SERVICE INFORMATION LETTER

SERVICE INFORMATION LETTER INDEX

FIGURE 3A

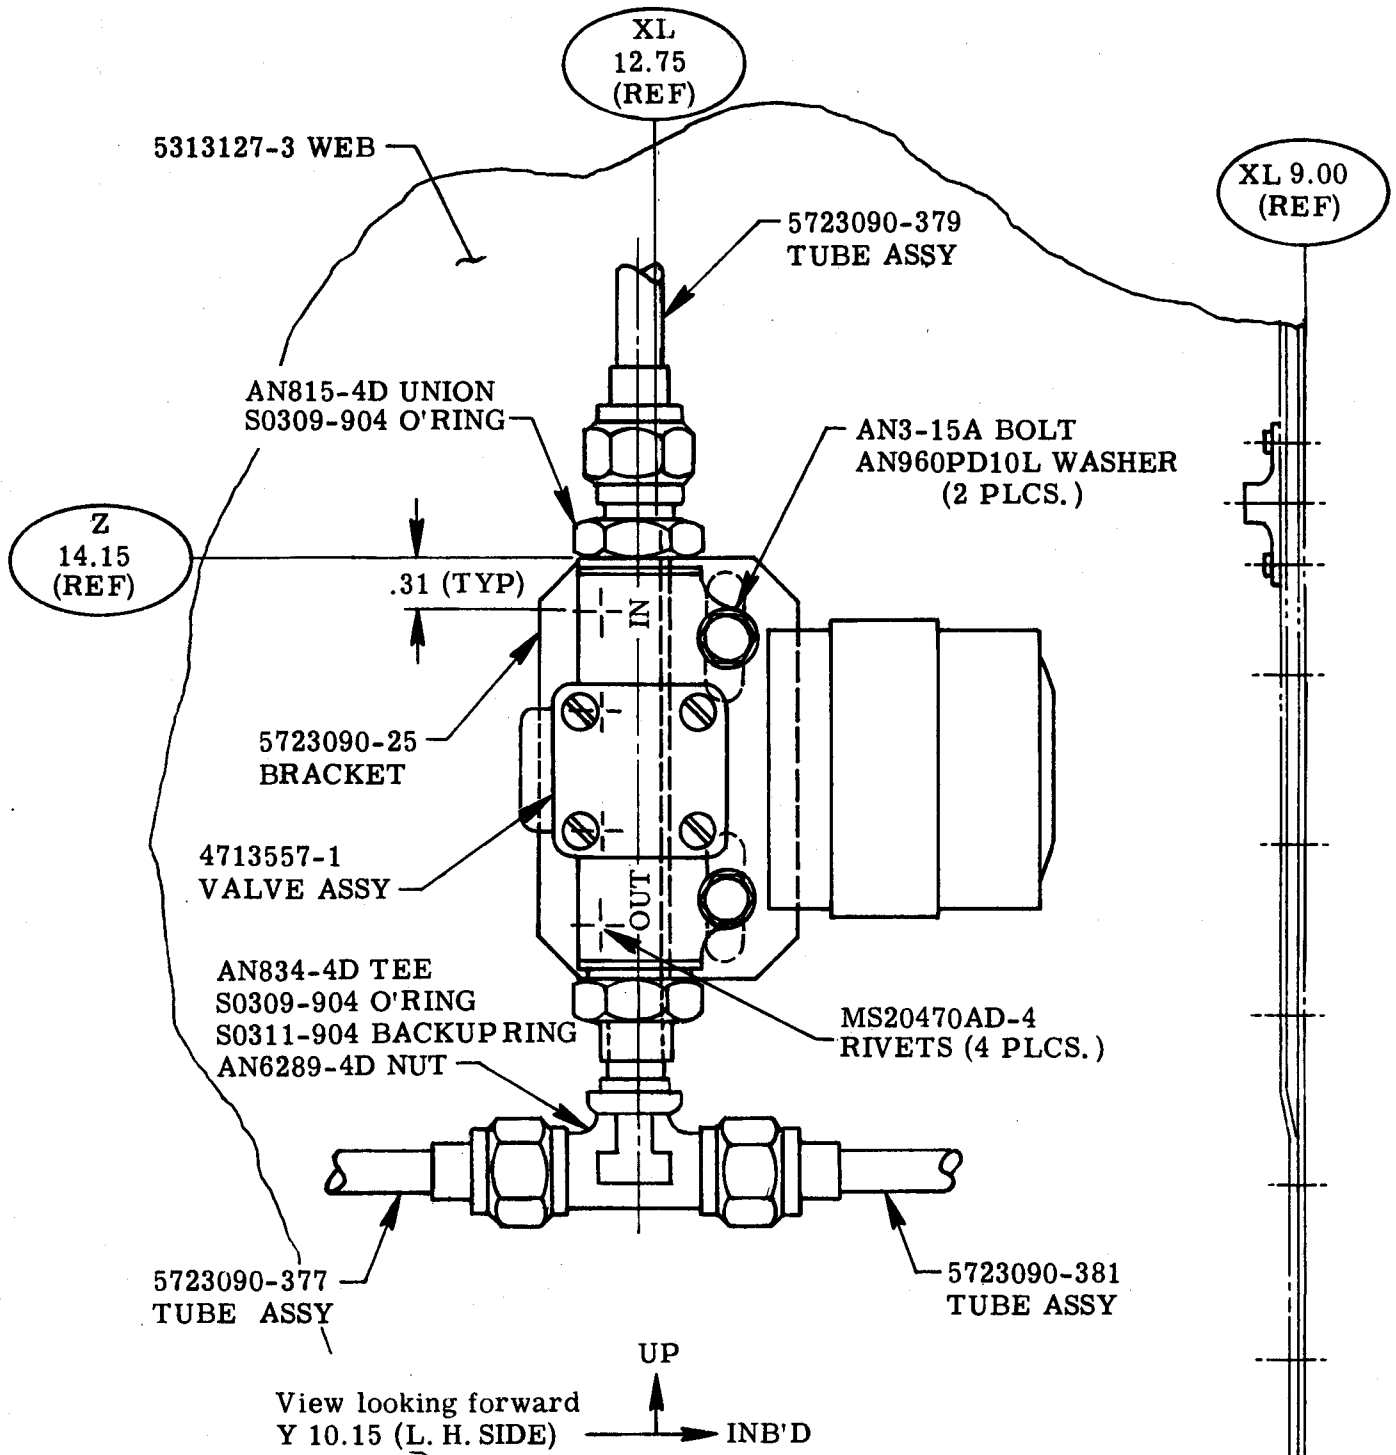
REASON FOR REVISION: TO CORRECT TUBING PART NUMBERS IN FIGURE 3A, CHANGE CONNECTOR PART NUMBER IN SUPPLY DATA AND ADD TUBE CLAMPING INFORMATION

1. Reference Figure 3A:
 - A. Tubing P/N 5723090-377 changed to 6723088-377.
 - B. Tubing P/N 5723090-379 changed to 6723088-379.
 - C. Tubing P/N 5723090-381 changed to 6723088-381.
2. The MS3106E-14S-9S Connector in Kit "B" is replaced by Connector P/N MS3456L-10SL-4S or MS3108B-10SL-4S.
3. Clamping information for tube P/N 6723088-349 or (-377) as applicable.
 1. Drill a 0.190 - 0.194 hole in the Y-10.15 bulkhead at the intersection of Fuselage Station X-16.0 and Z-21.6.
 2. Install hydraulic tubing support clamp P/N MS21919DG4, using an AN3-12A bolt, NAS43DD3-50 bushing and MS21042-3 nut.
 3. The required hardware for Para. 2 may be obtained from local source.

- B. Install the Solenoid Valve P/N 4713557-1 and the 5723090-25 bracket (Kit "B") as per Figure 3A.
13. Install the VXLA2500270D Restrictor with S0309-904 O-ring on the AN783-4D tee fitting, per Figure 4.

FIGURE 4A

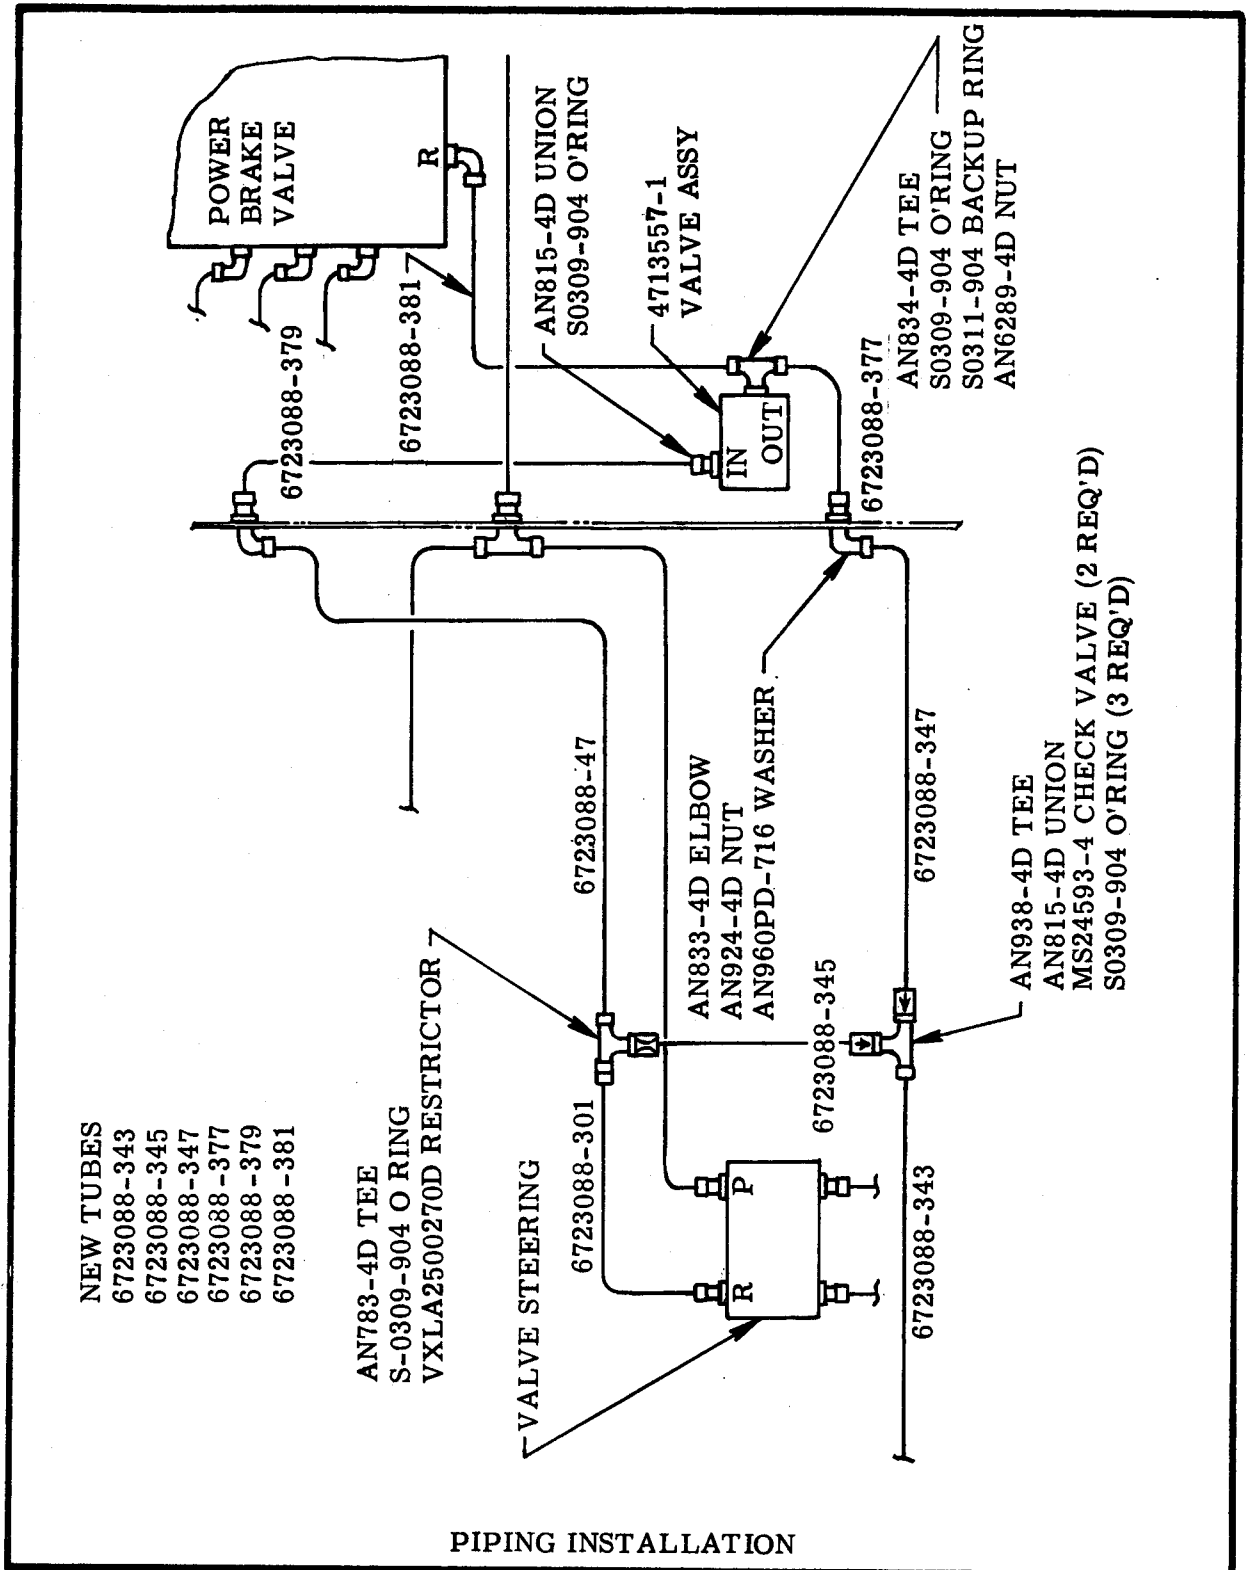
16. Install the AN783-4D tee between the -47 and -301 tube assys, in lieu of the AN938-4D tee removed in Step 14 B, as per Schematic Figure 4.
17. Refer to piping installation Schematic Figure 4 (Kit "A") or Figure 4A (Kit "B"), and install new hydraulic return tubing between the nose steering valve, solenoid valve, power brake valve, and the hydraulic return tube at the AN824-6D tee and the 6-TRTX-D reducer, as per schematic.

FIGURE 1

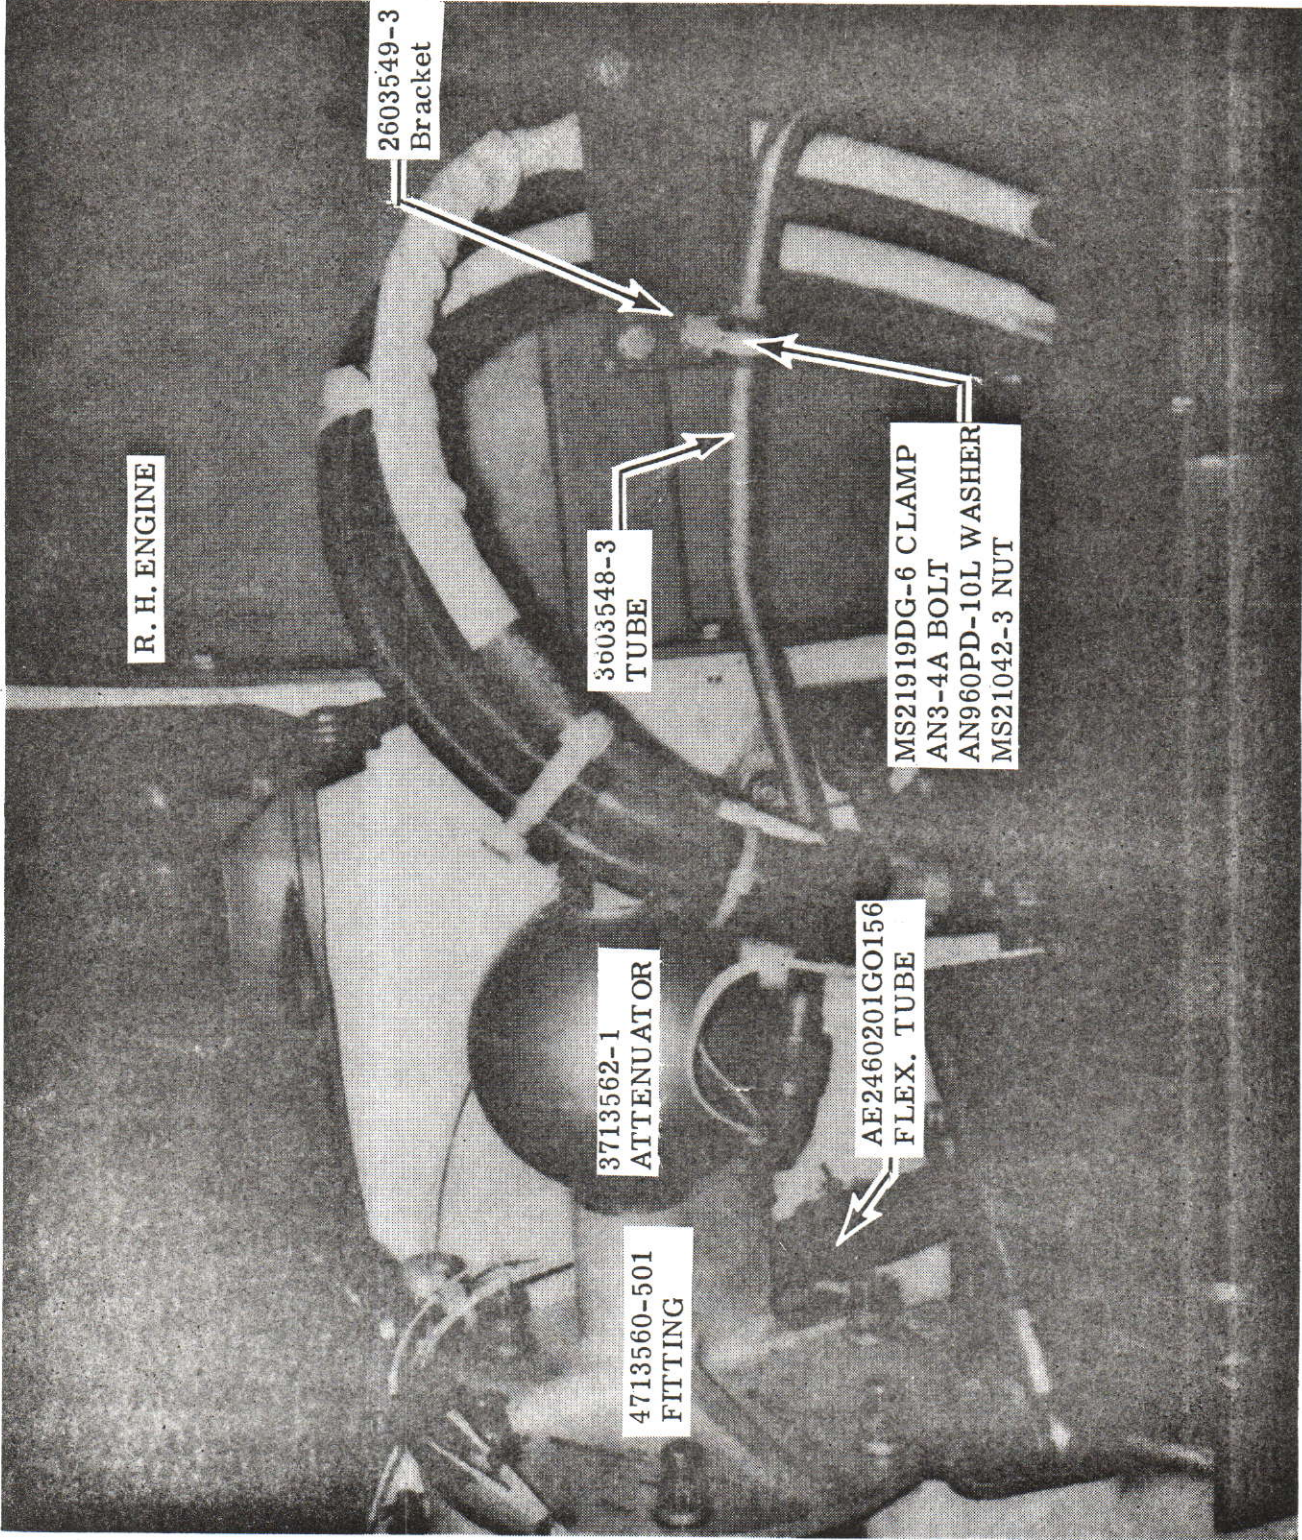
10. Remove and discard existing bracket P/N F10A-5-L20025-9, from right engine nacelle and replace with new bracket P/N 3603547-1. (See Figure 1).
11. Install an AN837-6J elbow, AN960C-916 washer, and AN924-6J nut on plate of bracket P/N 3603547-1, per Figure 1.

FIGURE 2

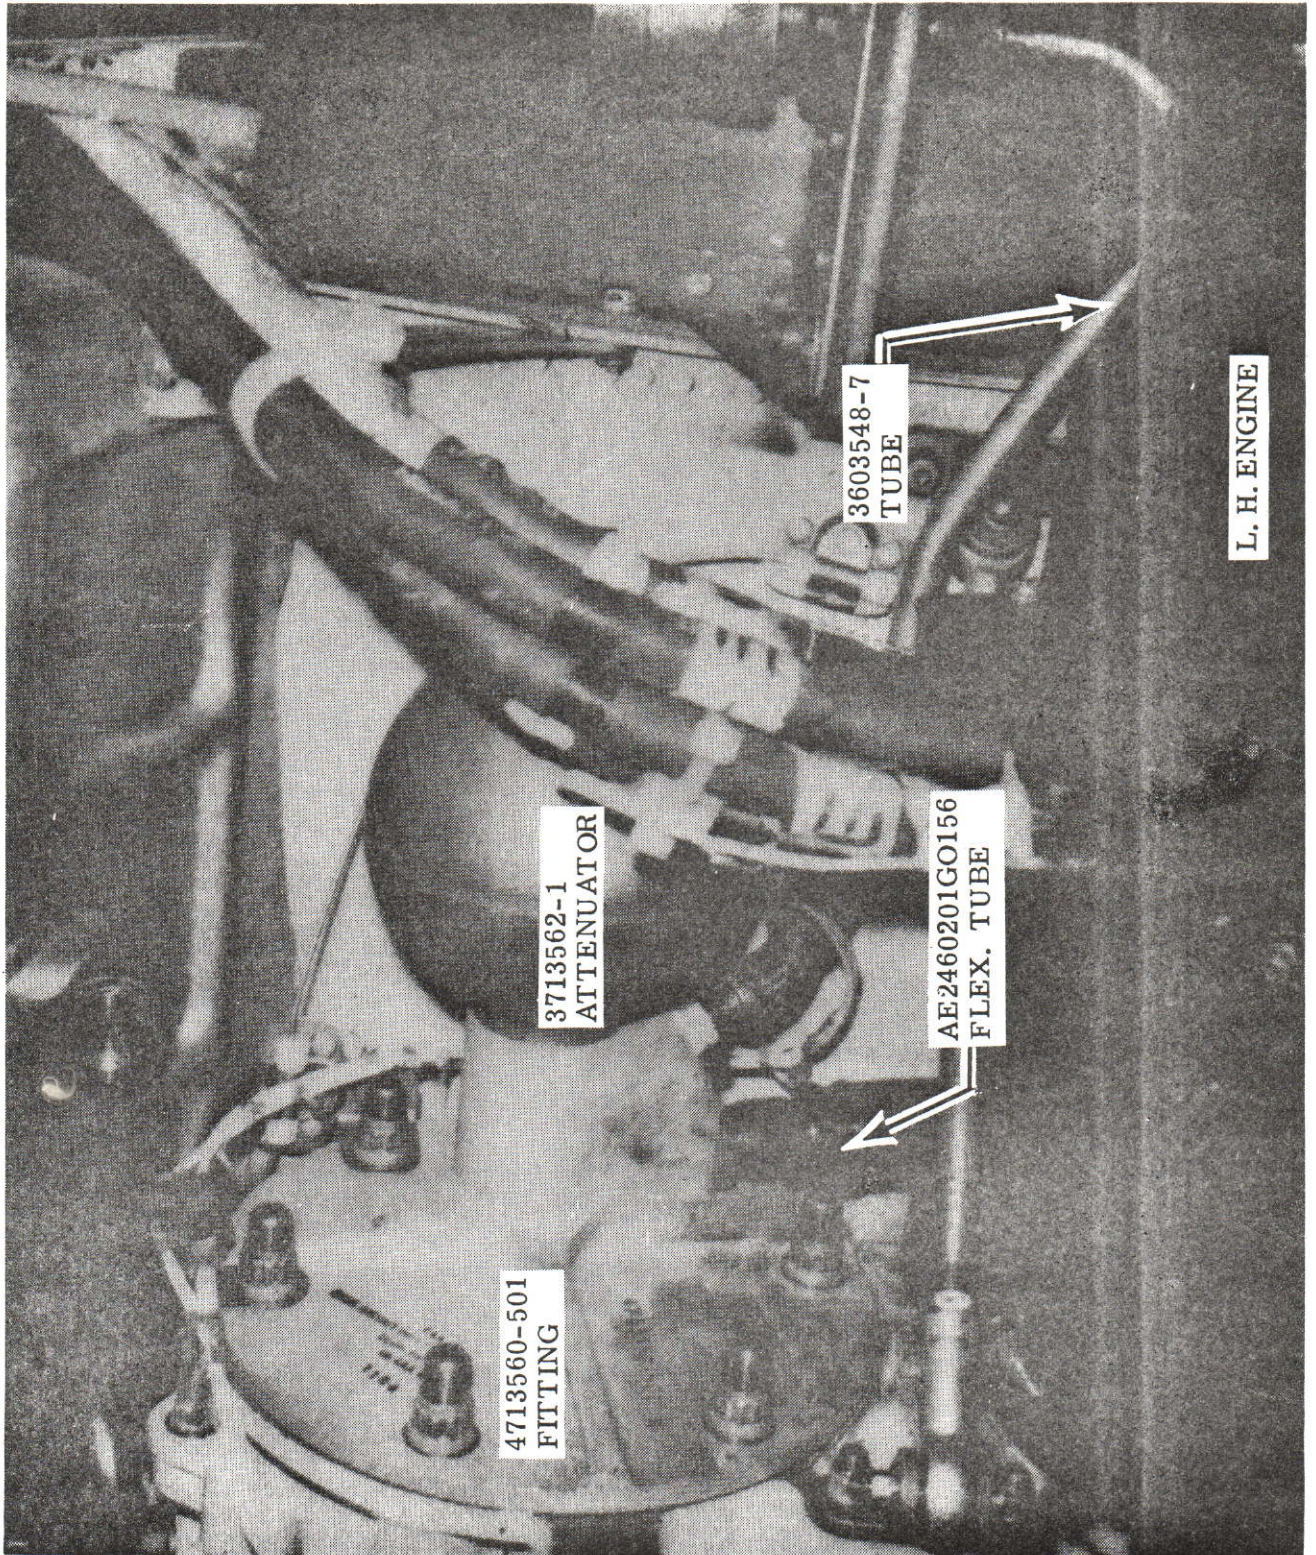
14. Install new tube P/N 3603548-3 between outlet port of fitting P/N 4714560-501 and the AN837-6J elbow, which was installed in Step 11.
15. Secure tube to wiring support block with MS21919DG-6 clamp, AN3-4A bolt, AN960PD-10L washer, MS21042-3 nut, and 2603549-3 bracket, per Figure 2.

FIGURE 3

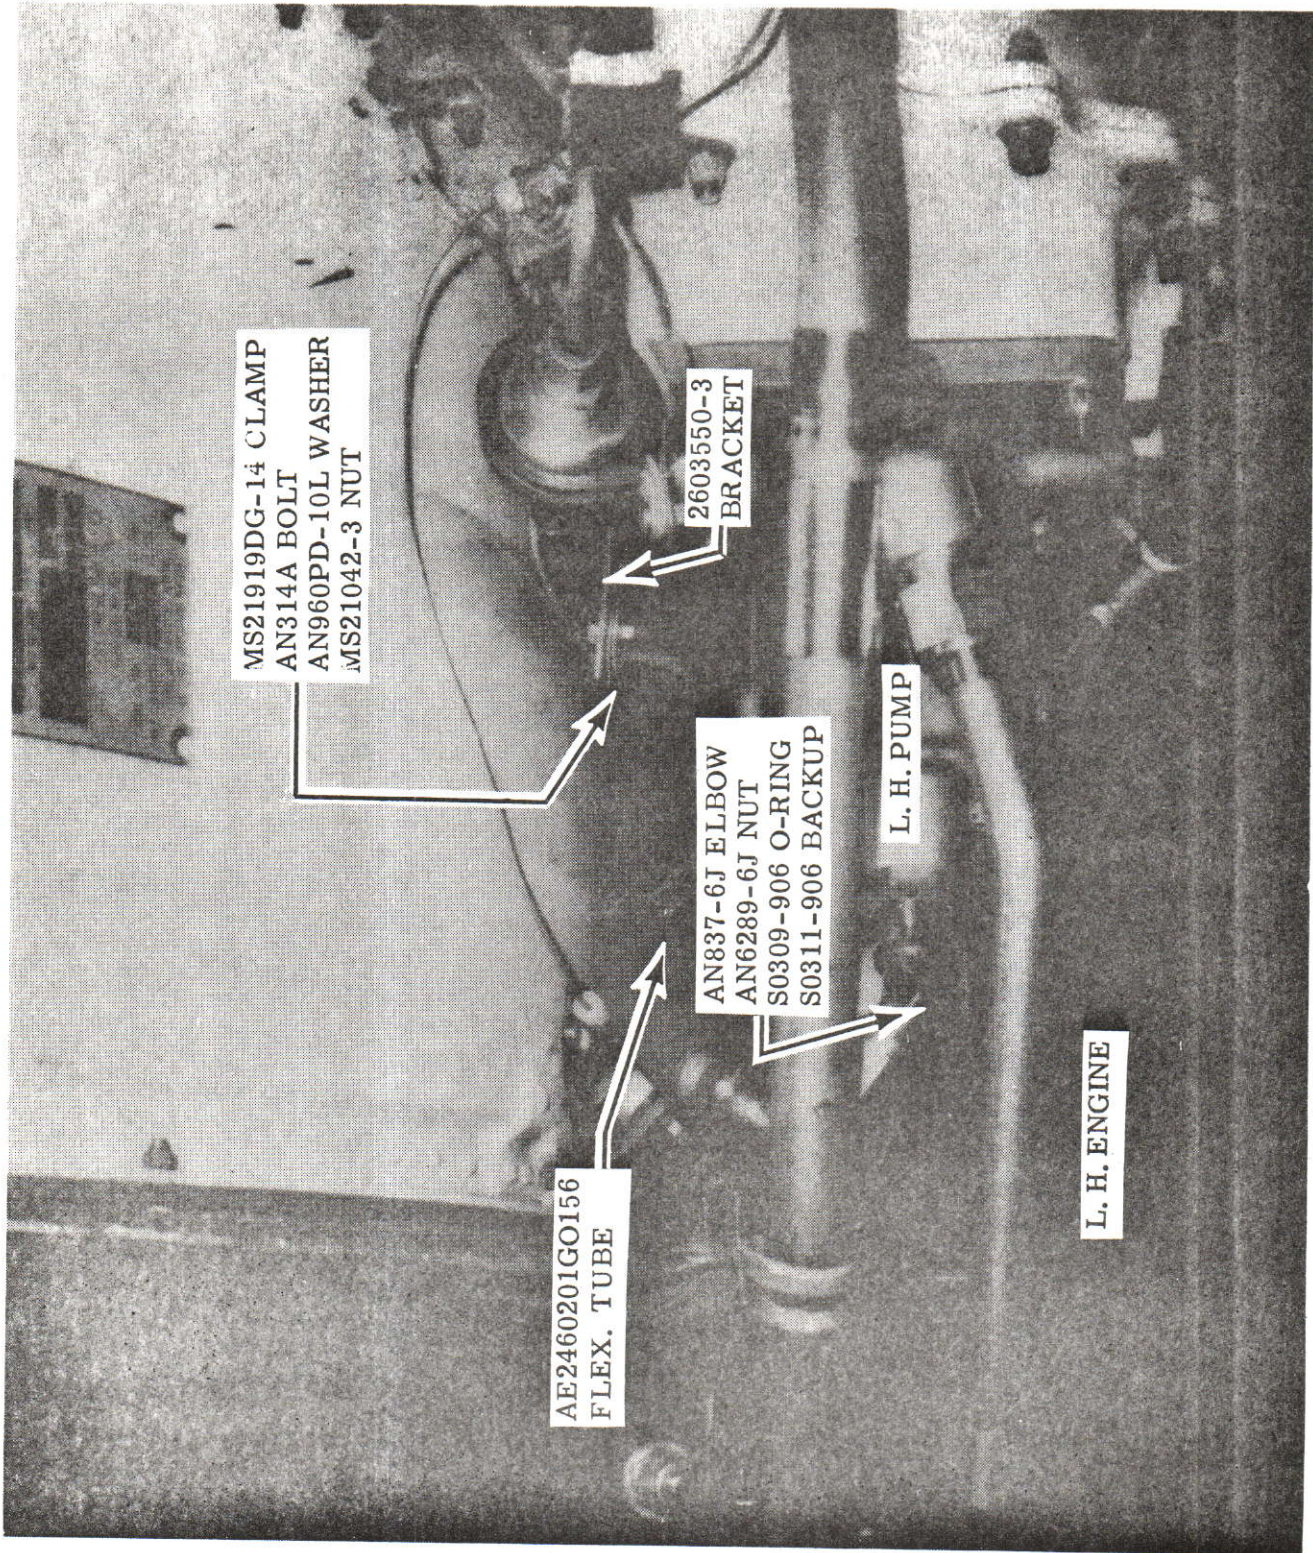
19. Install new tube P/N 3603548-7 between outlet port of fitting P/N 4713560-501 and quick disconnect fitting, per Figure 3.
20. Refer to Figure 6 and install a sleeve P/N 3713561-501, attenuator P/N 3713562-1, with a S0309-910 O-ring on each accessory drive pad fitting P/N 4713560-501. Torque and safety wire attenuators, per Figure 3.
